RFP-CSP #1006-26 – TOMBALL HS MULTI-PROGRAM ACTIVITY CENTER

Addendum No. 01

Addendum No:	01	**Issue Date:**	11/06/2026
Project:	Tomball HS - MPAC	**To Drawings + Specifications dated**	10/30/
Prepared By:	PBK Architects, Inc. 11 Greenway Plaza, 22nd Floor Houston, Texas 77046		
PBK Project No:	25046901

A110A - LEVEL 1 FLOOR PLAN - AREA A

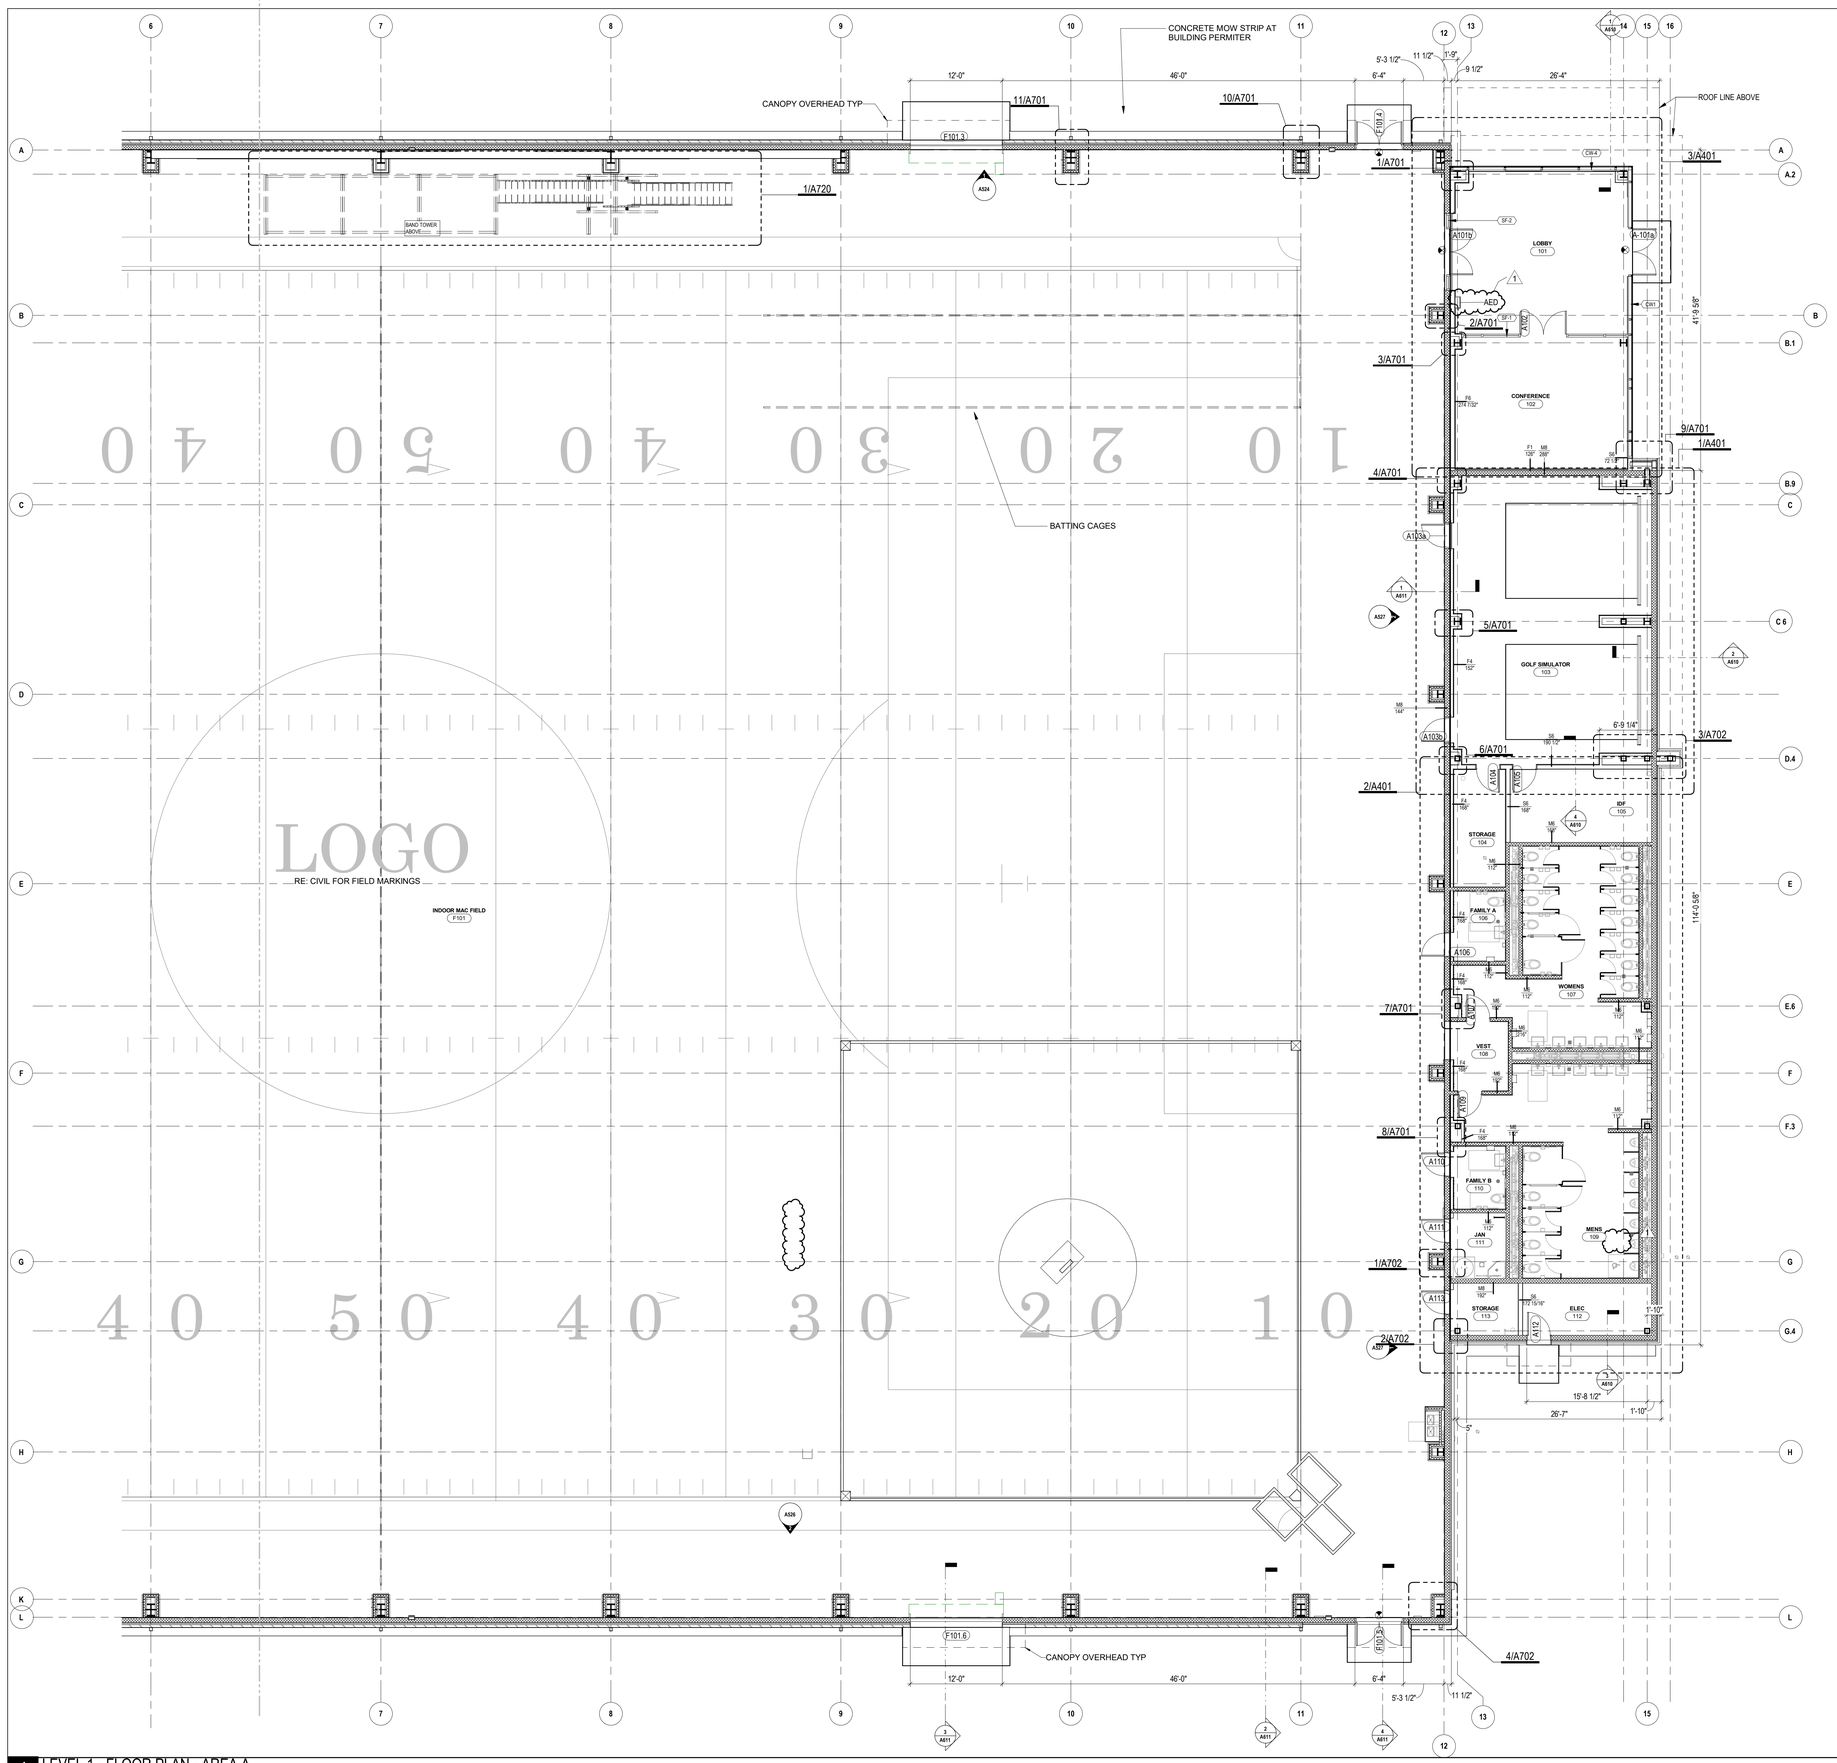
Item No. 2 **Sheet A110A LEVEL 1 FLOOR PLAN AREA A :**

b. **DELETE -**
c. **ADD** AED added in lobby area.

1 ROOF PLAN - COMPOSITE
1/16" = 1'-0"

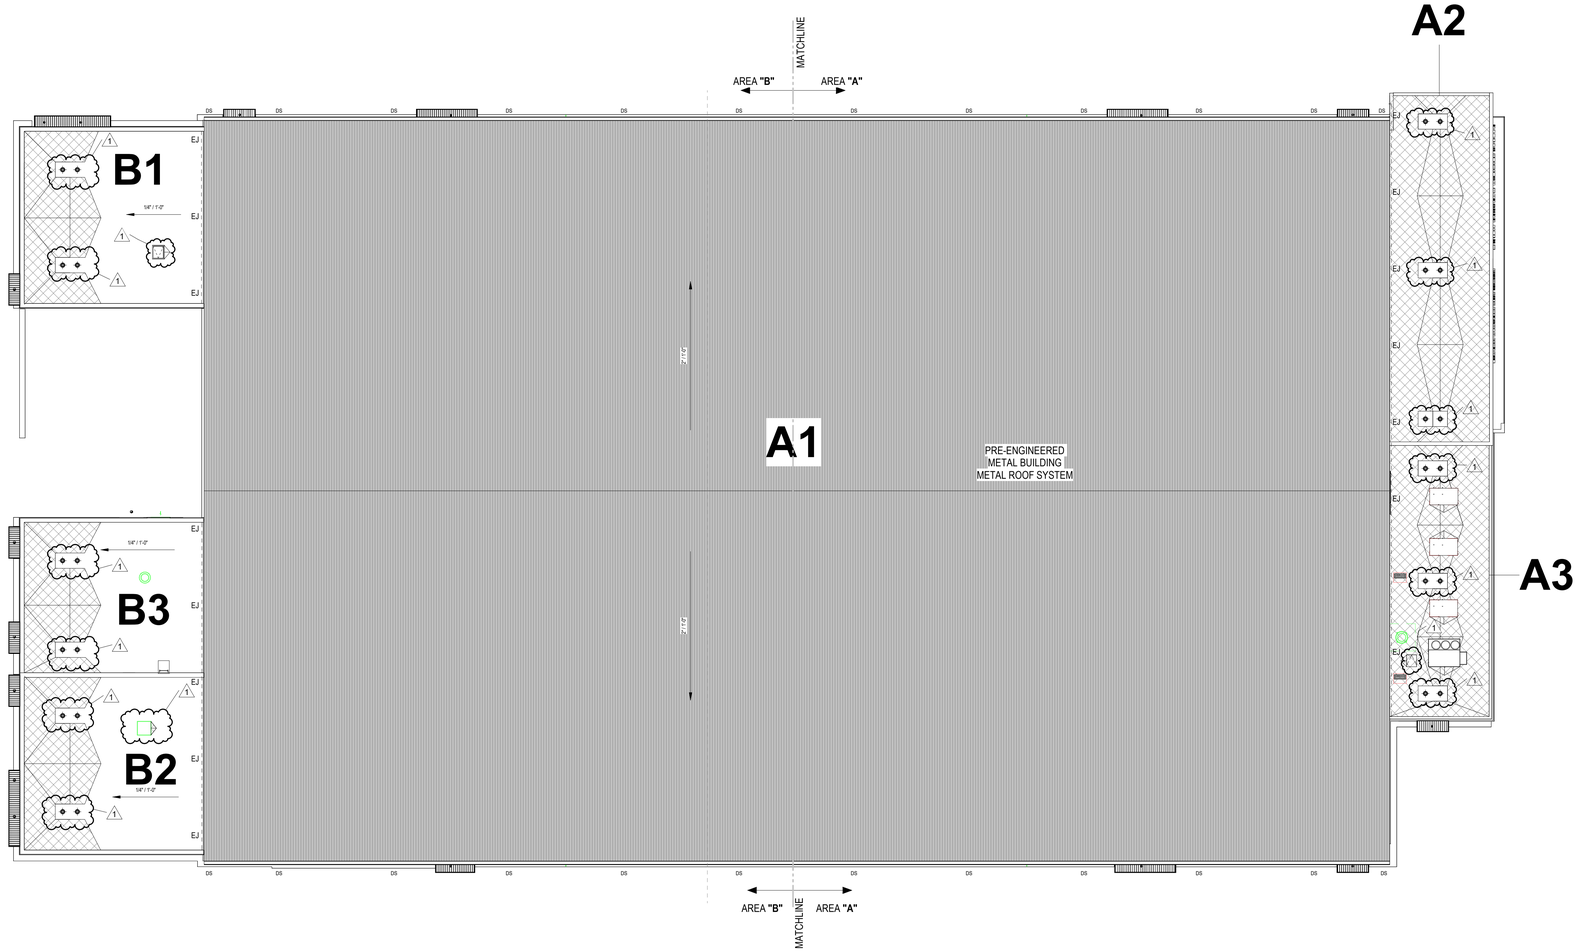
Item No. 5 **Sheet A301 ROOF PLAN OVERALL :**

f. **ADD** Revised cricketing to ensure overflow drains sit in same flat area as primary roof drains . Roof access hatch adjusted to match dimensions denoted on roof access hatch detail.

ENLARGED ROOF PLAN - AREA A

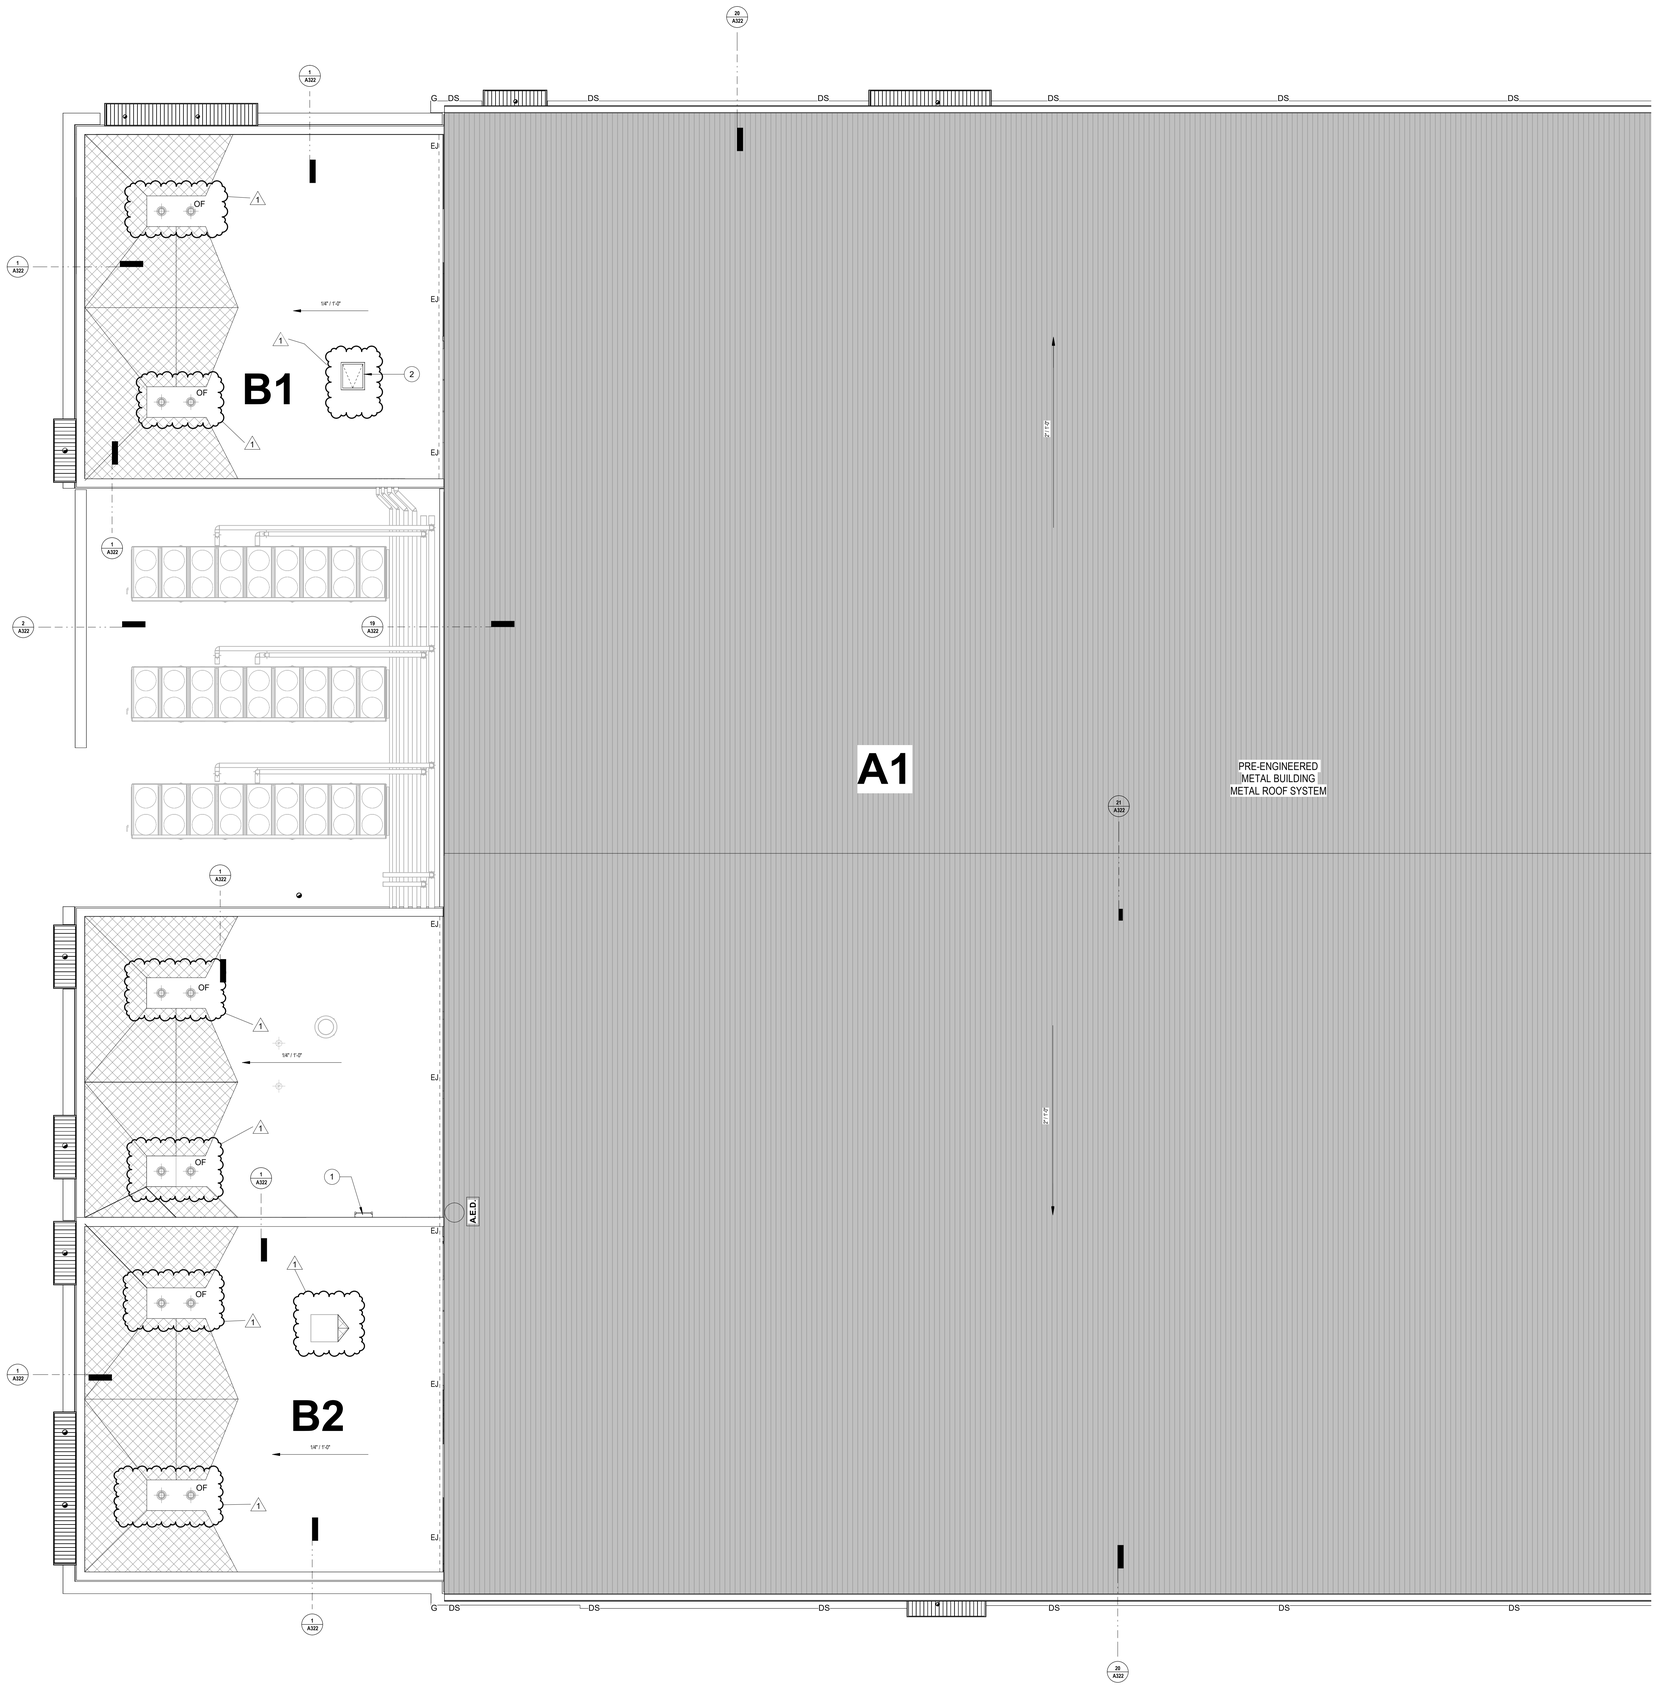
Item No. 6 **Sheet A301A ROOF PLAN AREA A :**

g. **ADD** Revised cricketing to ensure overflow drains sit in same flat area as primary roof drains . Roof access hatch adjusted to match dimensions denoted on roof access hatch detail.

A323 - EXPANSION JOINT DETAILS

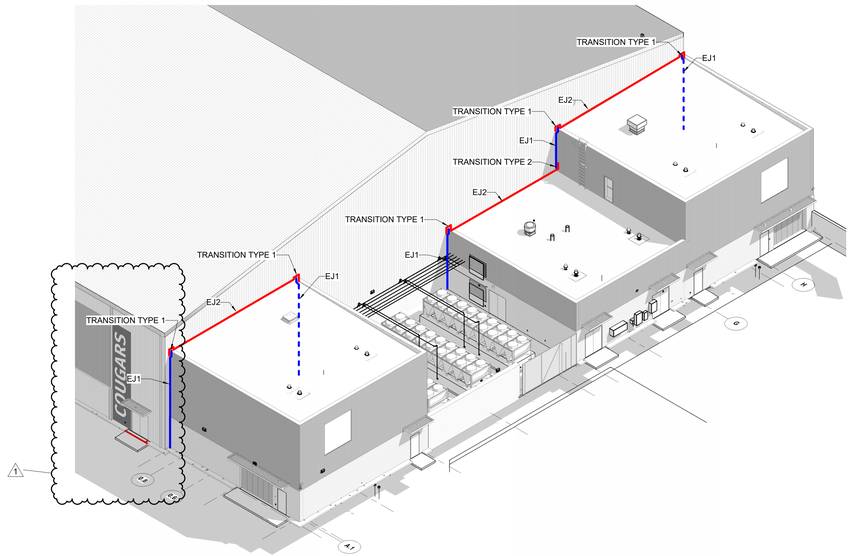
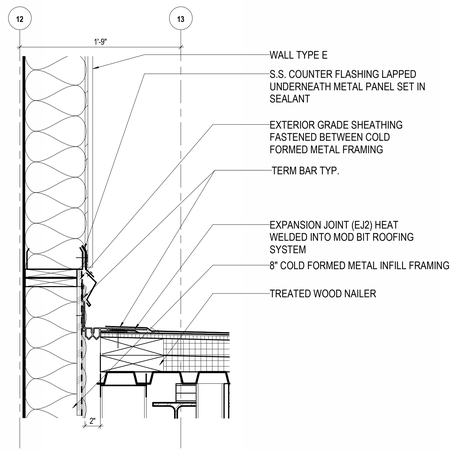
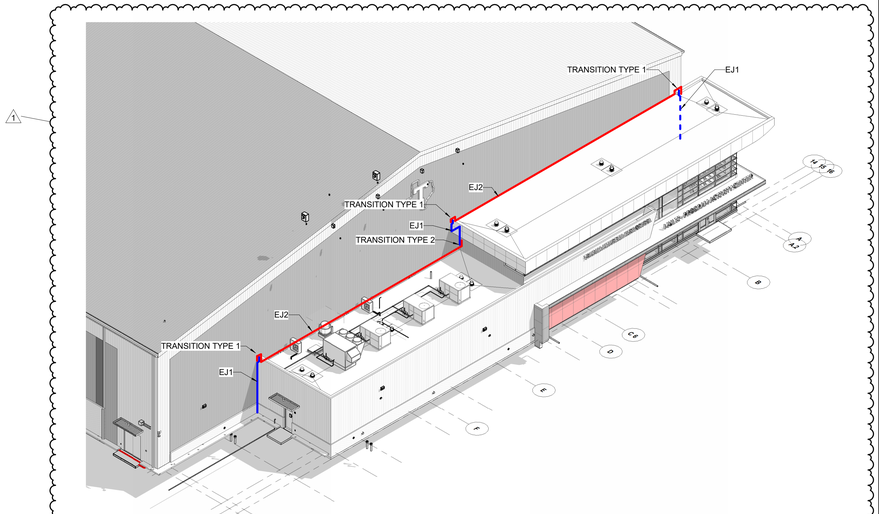
Item No. 9 **Sheet A323 EXPANSION JOINT DETAILS :**

j. **ADD** updated to show metal panel updates for overall elevations. No change to expansion joint detailing.

ENLARGED FLOOR PLANS

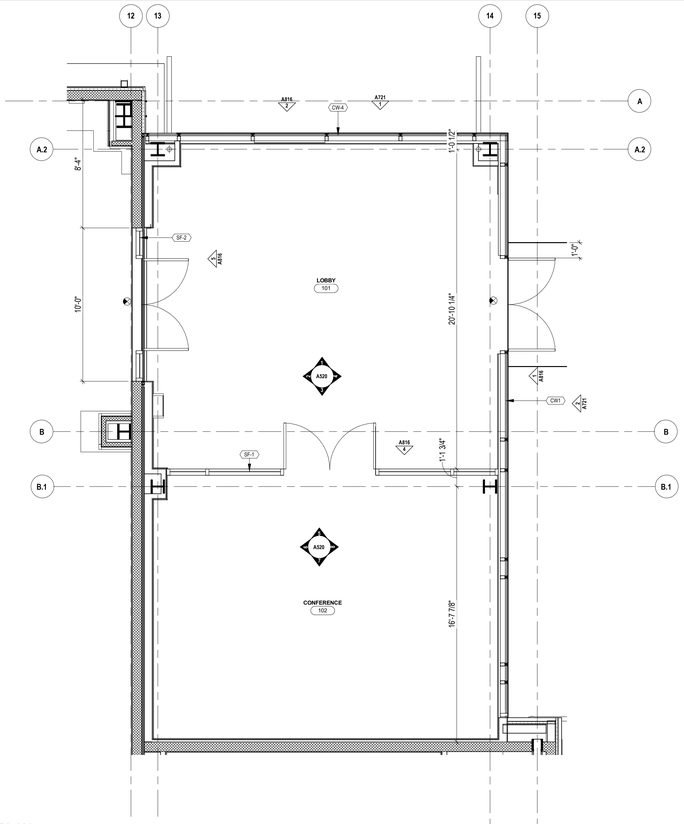
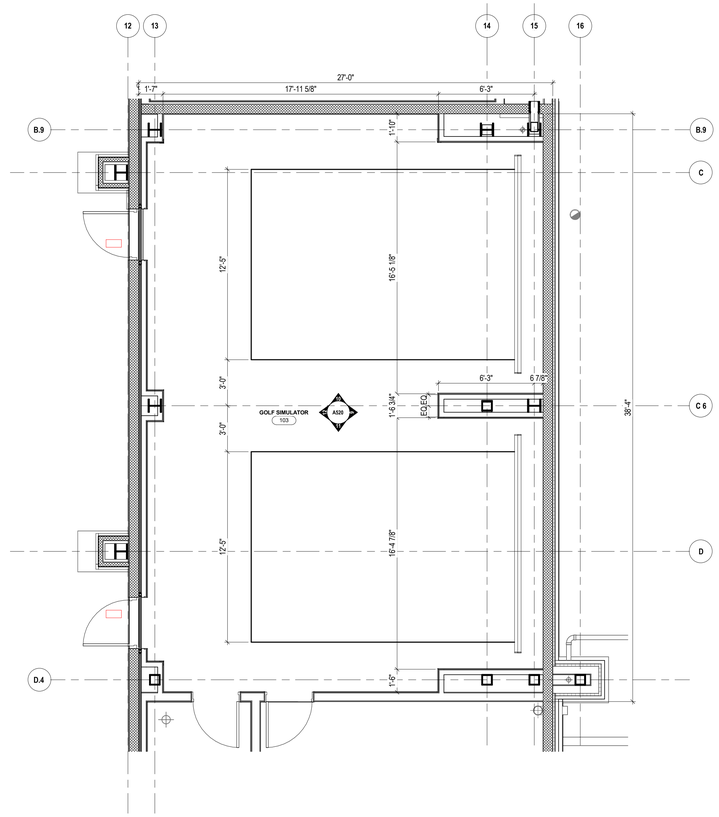
Item No. 10 **Sheet A401 ENLARGED PLANS :**

k. **Updated** to remove color from MEP model for clarity. Toilet accessories revised to remove items not required in this project.
